## **APPENDIX O**

### **COMMENTS ON THE DRAFT ENVIRONMENTAL IMPACT STATEMENT AND RESPONSES**

## Comments on Draft Environmental Impact Statement for the Southeast Market Pipelines Project, Including the Sabal (Sinkhole) Trail Pipeline

**PHMSA Pipeline Incidents: (1995-2014)**  
Incident Type: All Reported System Type: GAS TRANSMISSION State: ALL Offshore Flag: ONSHORE

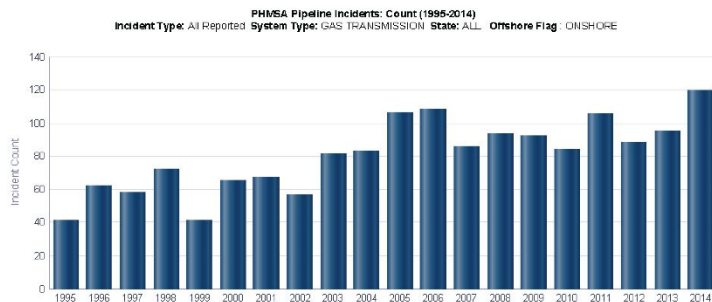
The table and chart below show the upward trend in gas pipeline incidents since 1995.  
<http://www.phmsa.dot.gov/pipeline/library/data-stats/pipelineincidenttrends>

CO25-20 We disagree. The data provided by the commenter presents the information for “All Reported” incidents. Our analysis in section 3.13.2 discusses significant incidents, which PHMSA defines as those resulting in fatality or injury requiring in-patient hospitalization; or \$50,000 or more in total costs, measured in 1984 dollars. The data from PHMSA does not show that significant incidents are increasing in frequency.

### 5.2 Newer pipelines failing more frequently than older pipelines

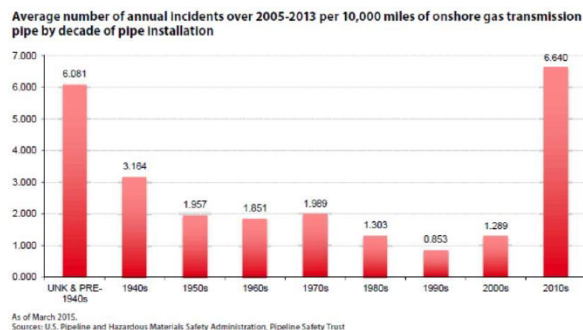
Even more troubling than the increase in pipeline accidents overall, a new study by the Pipeline Safety Trust found that newer pipelines are failing at a higher rate than much older pipelines. A disturbingly large proportion of pipeline failures in the past decade have occurred in newly-installed pipelines, as shown by the below chart:

Thus, FERC is wrong when it says on page 3-277 of the DEIS that “the frequency of significant incidents is strongly dependent on pipeline age. Older pipelines have a higher frequency of corrosion incidents because corrosion is a time-dependent process.” FERC cites a 1986 study for this assertion, which is clearly outdated. The recent analysis depicted in the above chart shows the exact opposite to be a correct conclusion, as more thoroughly explained below:

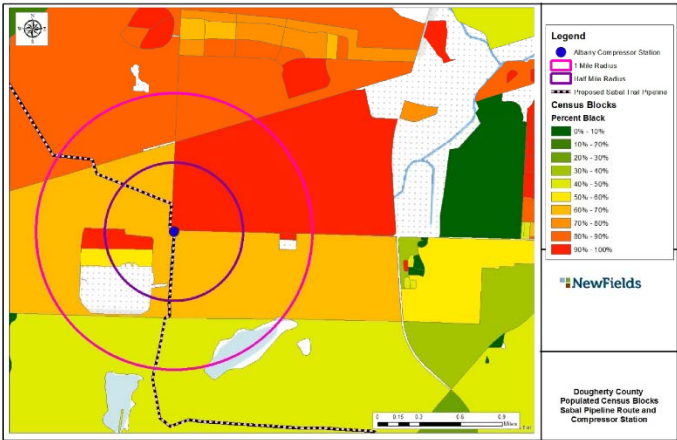
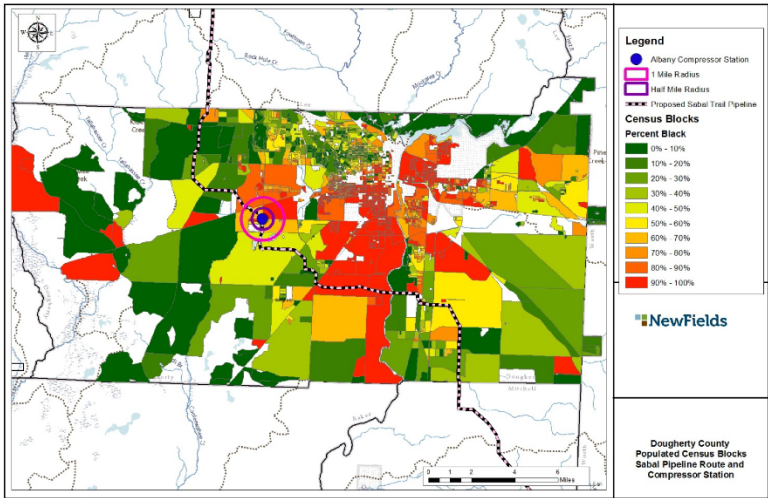
Most astoundingly, FERC states in conclusory fashion, with no supporting analysis at all, that the proposed location for the Station does not lie within an EJ community.<sup>65</sup> FERC makes no effort to address the evidence submitted in previous comments showing that the Station location would be right in the middle of a majority African-American residential community that includes a mobile home park (Countryside Village Mobile Home park), two subdivisions (Winterwood and Indian Creek), four schools (Robert Cross Middle School, Deerfield Windsor High School, Live Oak Elementary School, and Alice Coachman Elementary School), the 5,000-plus member Mt. Zion Church, and recreational facilities (Exchange Club Fairgrounds, Stoneridge Subdivision golf course, and the YMCA). Five other compressor stations for this proposed project are located in much smaller populated areas.

Additionally, although the site of the Station is in a majority white census tract, the actual location of the Station would be in a majority African-American area on the northern periphery of the majority white area. More specifically, 100% of the residents within the census block occupied by the Station are African-American, 84% of the residents within a one-half mile radius of the proposed location are African-American, and 82% of the residents within a one-mile radius of the proposed location are African-American.<sup>66</sup> The following diagrams illustrate this racial breakdown:

Figure 1. Location Map of Sabal Trail Pipeline, selected crossings, HDD Suwannee River, and HDD under highway 90.

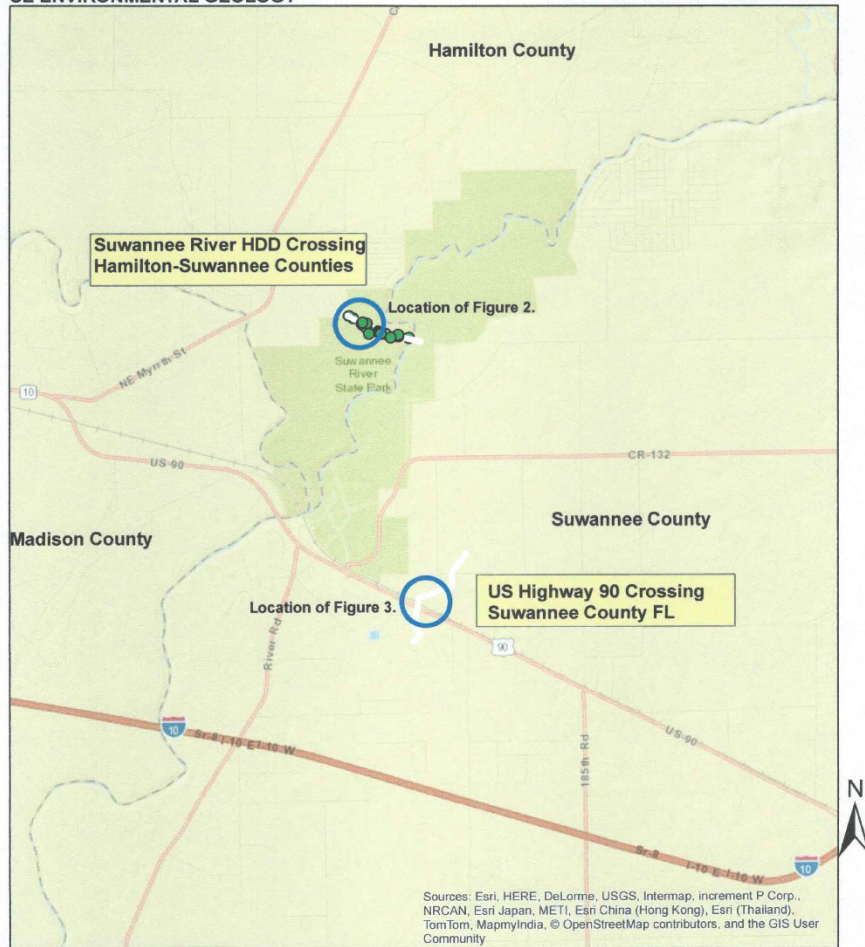
Attached are Figure 1 and Figure 2 and two Photographs. Figure 1 is the Location Map showing the route of the pipeline as it crosses the Suwannee River through the Suwannee River State Park (SRSP) property in Hamilton County. This area is in the Floodplain of the Suwannee River. It also shows the location of the route as it begins its crossing of US Highway 90.

The location map also shows where the pipeline route will be bored under US Highway 90 and that location relative to the Suwannee River crossing. The location of the pipeline route here is taken from Sabal Trail documents. Sabal Trail documents also reference and have maps showing the Falmouth Springs (Karst Window) cave system. That cave system has to be crossed in order to follow their pipeline route. The cave system is roughly located on the attached LiDAR map (Figure 3.).

CO31-1 See the response to comment FA2-27 and sections 3.1.2.3 and 3.3.1 of the EIS which adequately characterize geologic and hydrogeologic setting in the project area.

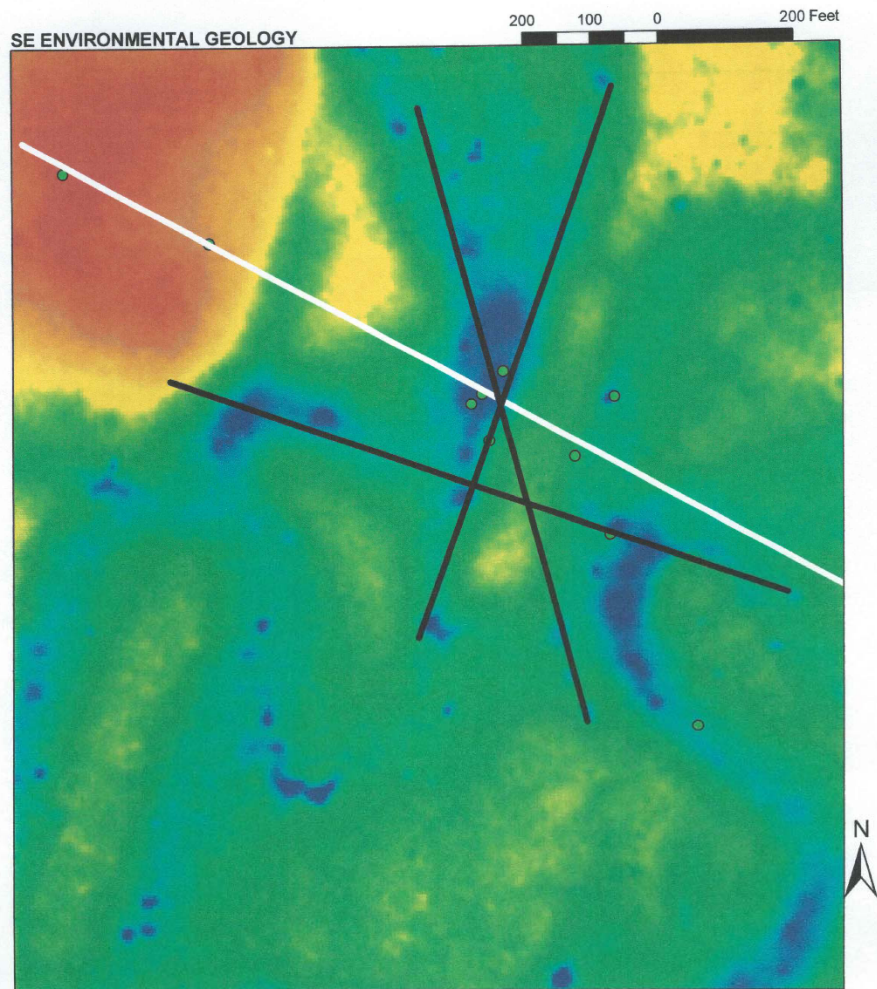
Figure 2 is a LiDAR Topography Map of a portion of the trail as it first enters the SRSP. The color scheme on the map is a representation of the topography with the highest elevation a warm brown and the lowest elevations a dark blue. Initially field work was performed to locate the pipeline route using GPS and then locating sinkhole features along its route at the specified location on the map. These coordinates were then entered into ArcView (software) and placed on the map in order to draw the pipeline route. This route was then compared with Sabal Trail Documents which located the pipeline route in the exact same location, plus or minus approximately 35' either direction.

Figure 3. LiDAR Map of Selected Location of Sabal Trail Pipeline as it approaches US Highway 90. The pipeline route passes over the Falmouth cave system. Limestone within the designed sinkholes is at about 32' NGVD. Land surface where the pipeline crosses the cave system is about 63' NGVD.

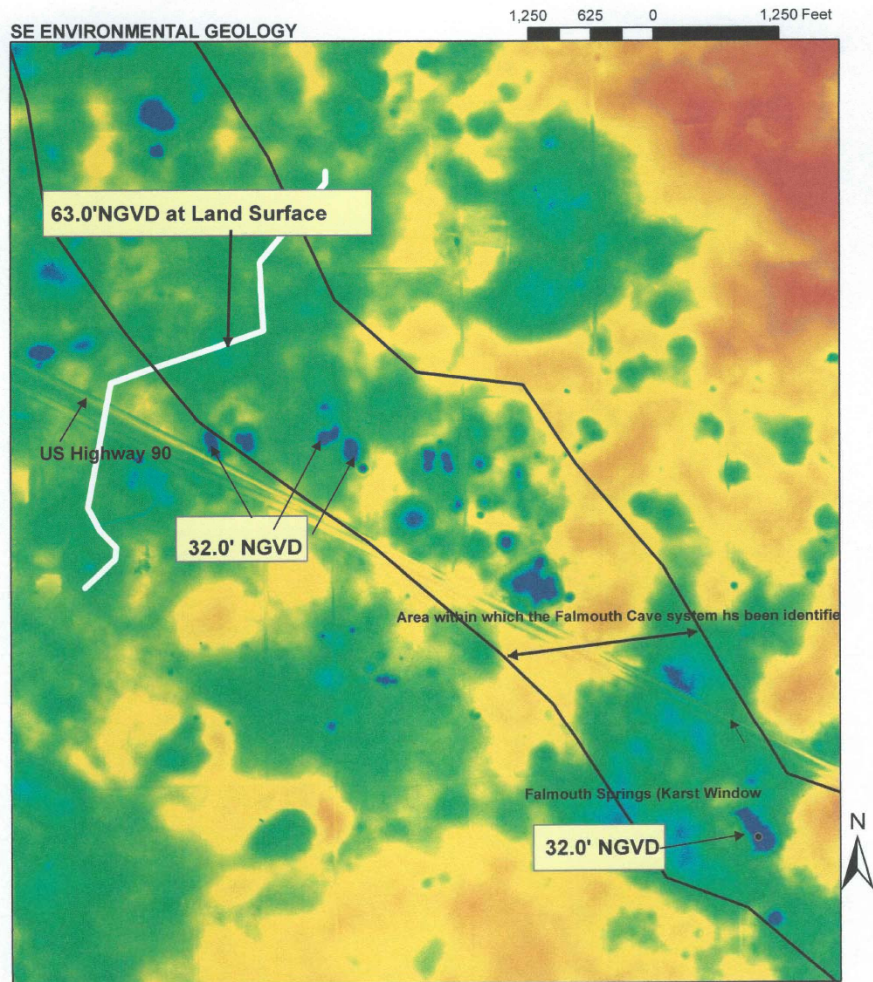
The Falmouth Cave system is an economic resource in our rural area. Divers from all over the world come to Suwannee County to dive and explore numerous cave systems. Falmouth is one of these cave systems. Divers have documented that along the cave system, they encounter additional Karst Windows which they surface in and replace empty air tanks with full ones to continue the dive.

Our worry is that excavation for pipe lying across the Falmouth cave system and the boring depth under US 90 will result in collapse into the cave system. The karst mitigation plan describes how sinkhole features that appear during construction will be restored. When caverns are encountered, they propose completely filling the void with cement and then filling the hole.
